Internal alterations and enlargement of existing house.
At 4 Harbour Lane South Queensferry EH30 9PT

Application No: 21/01809/FUL

DECISION NOTICE

Report of Handling

NORTH ELEVATION

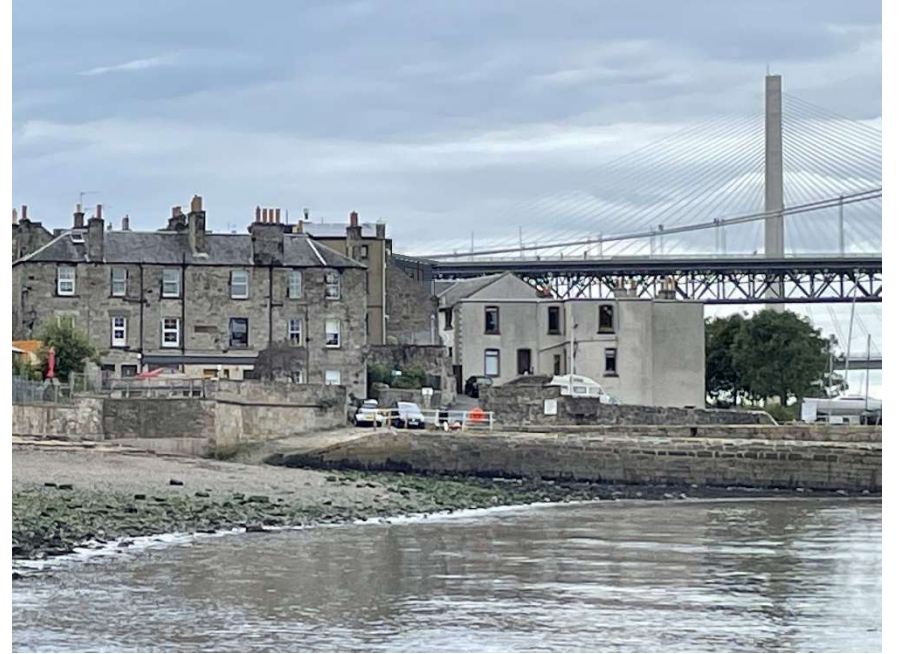
- 4.10 Researching the history of this building, the roof has always had north-facing windows protruding from the roof. The proposed elevations are "true" elevations in that they show the full elevation as a single aspect. The Applicants and AGL Architect would like to reinforce to the LRB that north-facing windows will never be seen as a full elevation due to the site constraints and only slim portions of the building which are visible.

4.24 Below are examples of asymmetrical roofs:

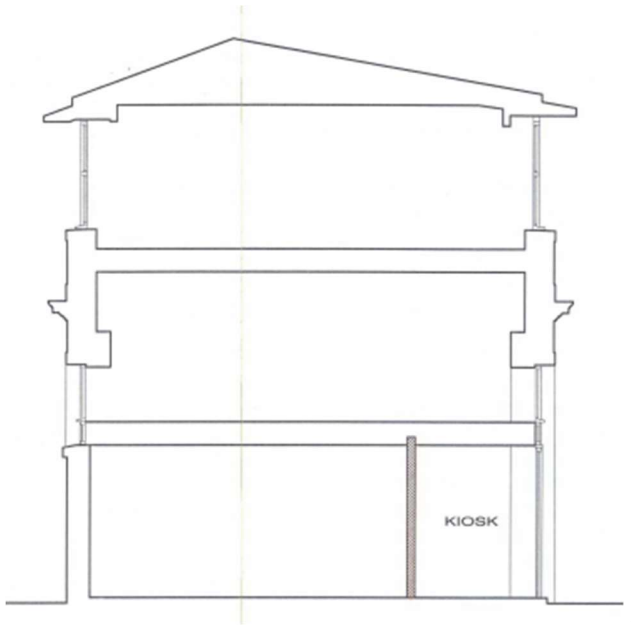
- 4.23 AGL Architect consider the asymmetrical design of the roof does not have a significant effect on the area as it is hidden by neighbouring buildings. The incorporation of the balcony on the East gable of the roof helps reduce the visible impact from the East and allows for the design to blend in with the house and surroundings.

Gote Lane

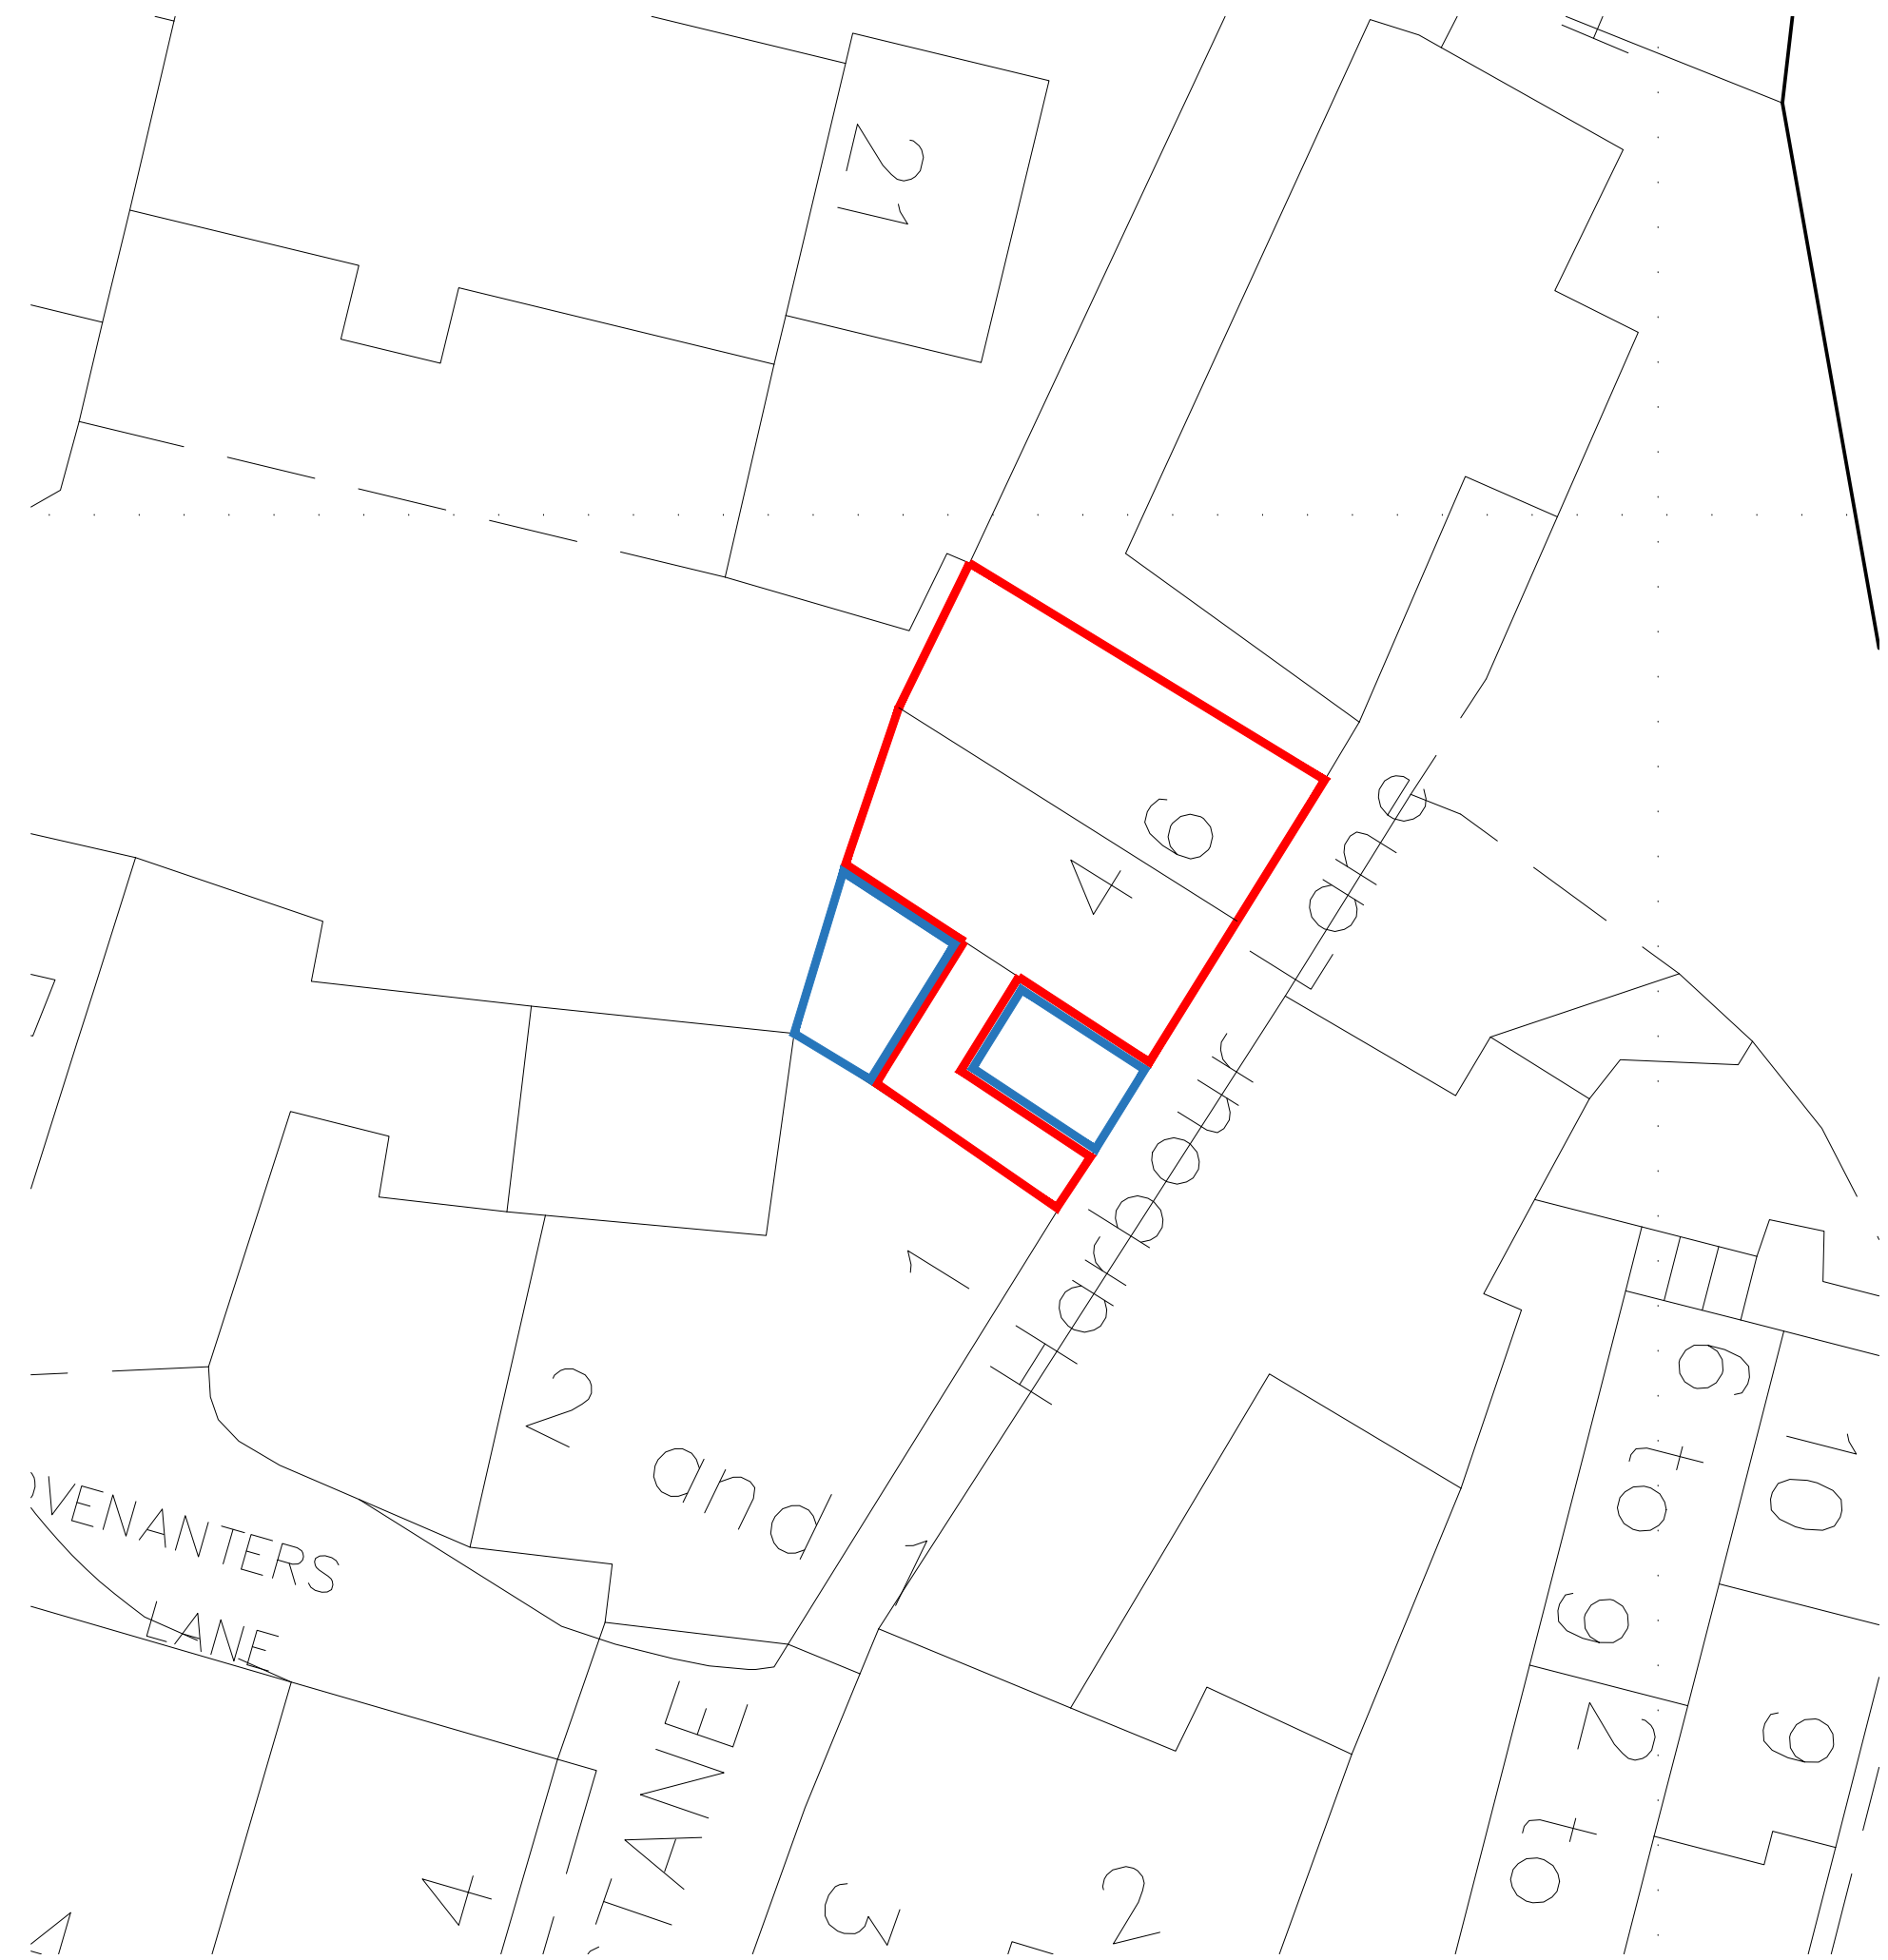
- 4.20 Off Gote Lane in Hillwood Place, a similar development has been done to make the most of the view, further along in the binks and down Shore Road Mansard roof designs have been used to provide views of the Forth. Houses on Station Road have altered roofs to include wide window roof balconies which we imagine have been permitted to allow for a view of the Forth bridges². (Appendix 4)
